MEMORANDUM

SUBJECT: February 5, 2026 HISTORIC PRESERVATION COMMISSION SPECIAL MEETING

Certificate of Appropriateness

815 West Beverley Street

815 W. BEVERLEY ST EXISTING PORCH
NORTH ELEVATION TO BE SCREENED
NOT VISIBLE FROM STREET

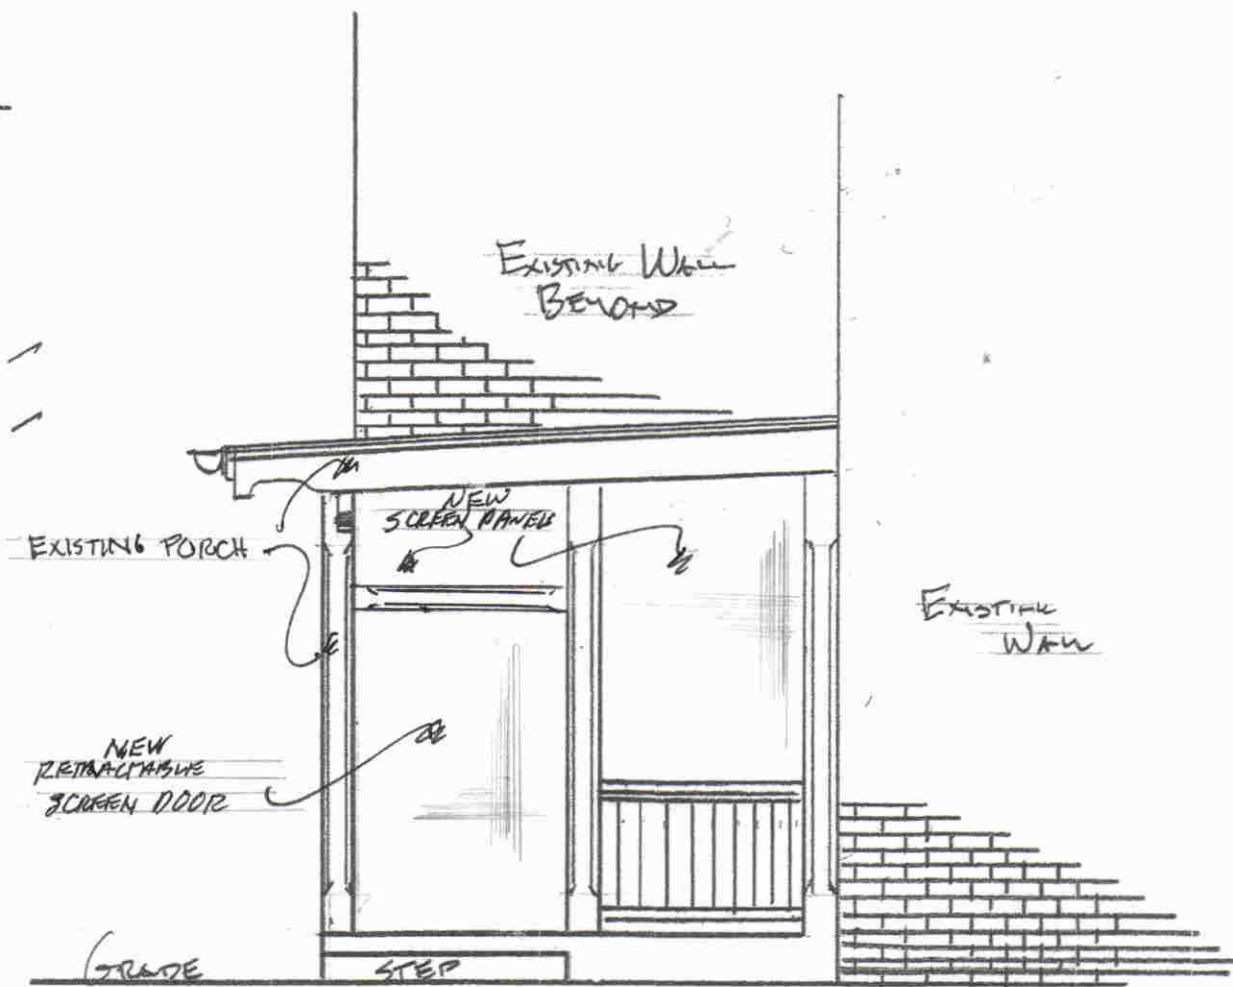
HSF Recommendation: HSF recommends the certificate of appropriateness be approved. The porch is located at the side and toward the rear of the house with limited view. The treatment does not enclose the porch and will not alter the size, scale, or materials of the porch.

Sample Motion: I move the Certificate of Appropriateness be appropriateness be approved as submitted.

PROPOSED EXTERIOR RENOVATIONS
for
ARCADIA PROJECT-DIXIE THEATER

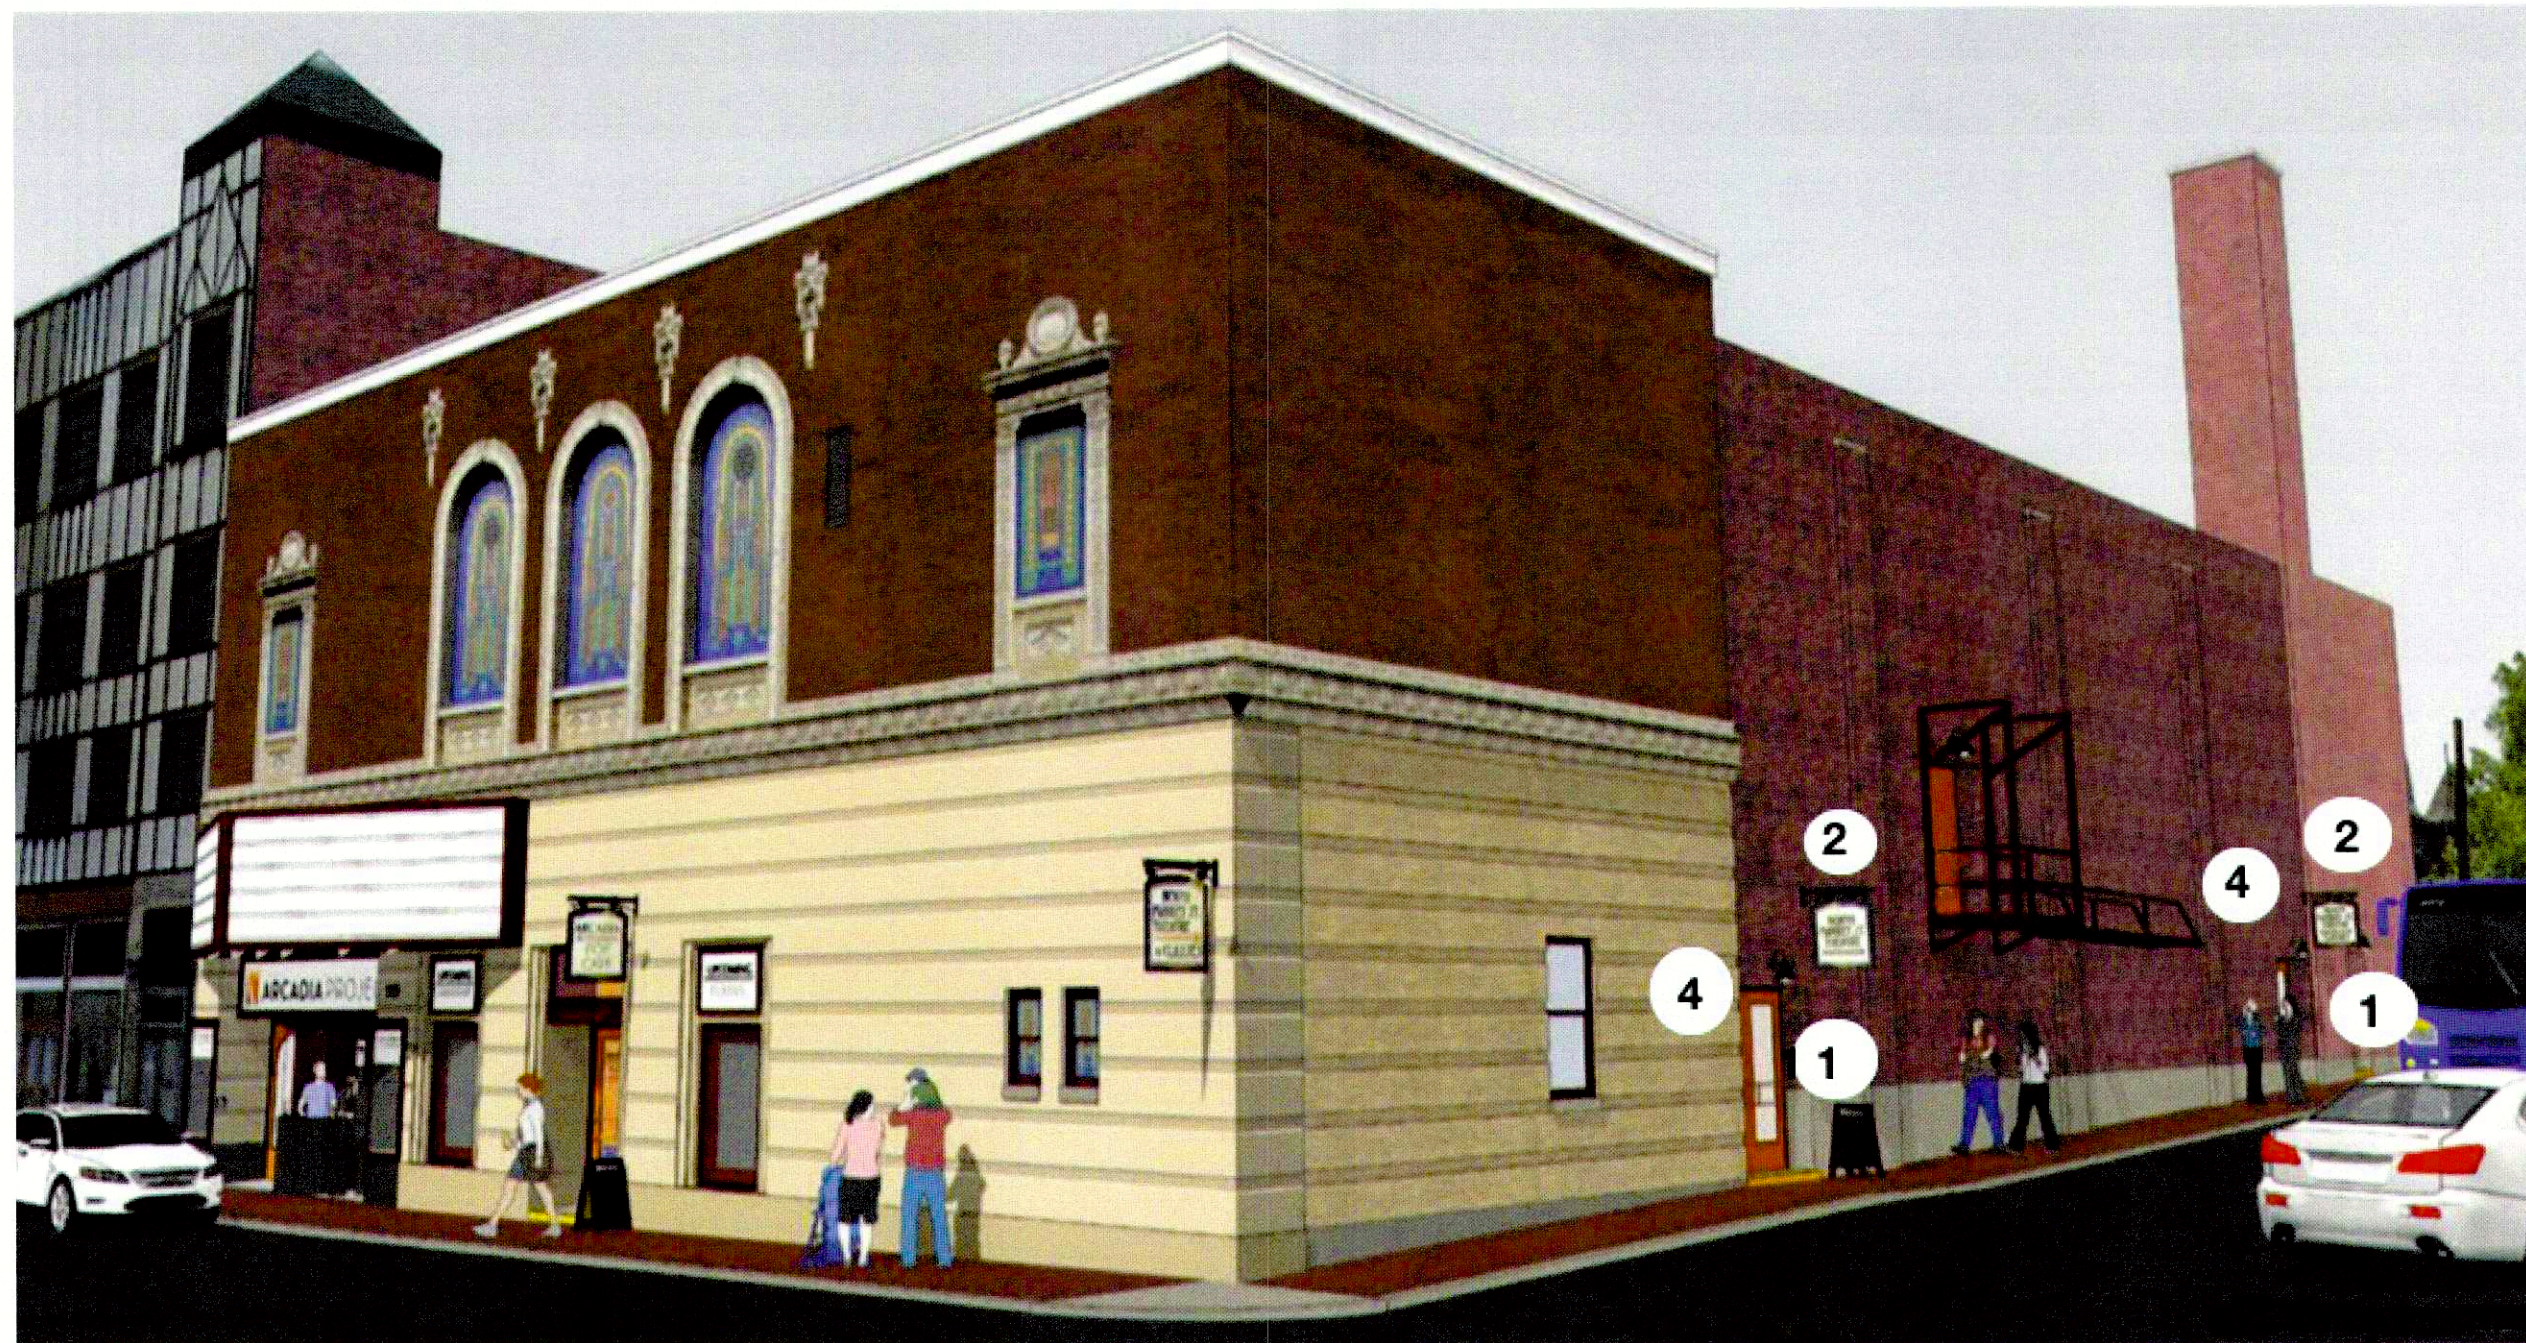
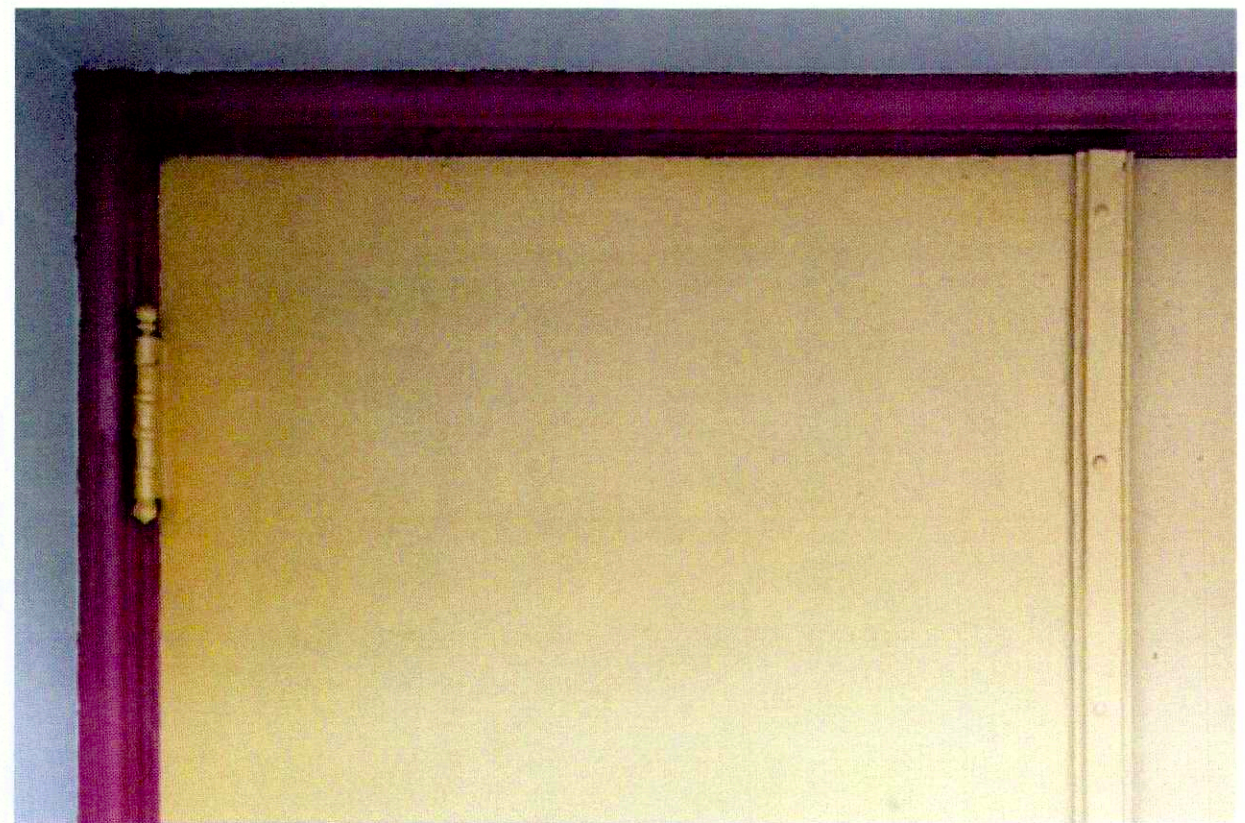
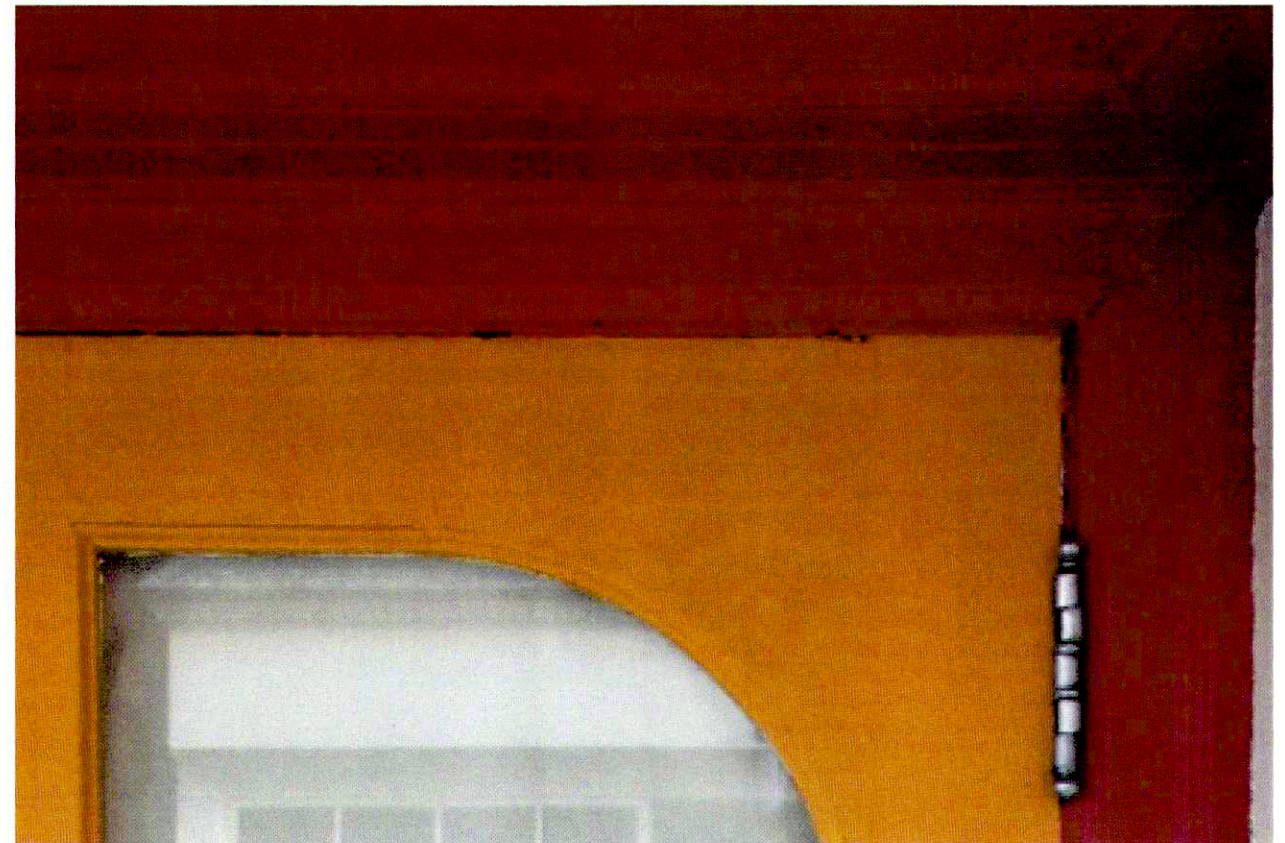
1. Replace the existing flush hollow metal exterior doors on the Beverley Street and Market Street facades with new hollow metal and full obscure glass panel doors. The metal portions shall be painted to match the color of the existing wood entry doors.

4. Replace the existing utilitarian style wall mounted light fixtures, located above the exit doors, on the Market Street facade with new shaded light fixtures in a design that is more appropriate with the design of the building and compliments the design of the signage brackets.
